## Service Bulletin Computer Monitors

**Model:** CPD-15SF2, CPD-17SF2

**No.** 124

**Subject:** Countermeasure for Unstable Picture or Power  
Save due to no Vert. Sync.

**D Board Schematic Change**

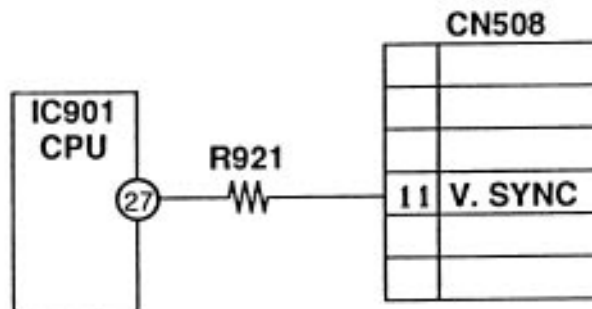
If picture is unstable when using a computer having a low Vert. Sync. level of Approx. 0.7 V. The monitor may go into the Power Save mode due to conditions like having no Vert. Sync. input signal.

Then, please perform the following countermeasure on the D Board.

REF	DESCRIPTION	PART NUMBER
R921	2.2 K 5% 1/4 W	1-249-421-11

1. Replace R921 with the 2.2K Ohm part. See illustration below.
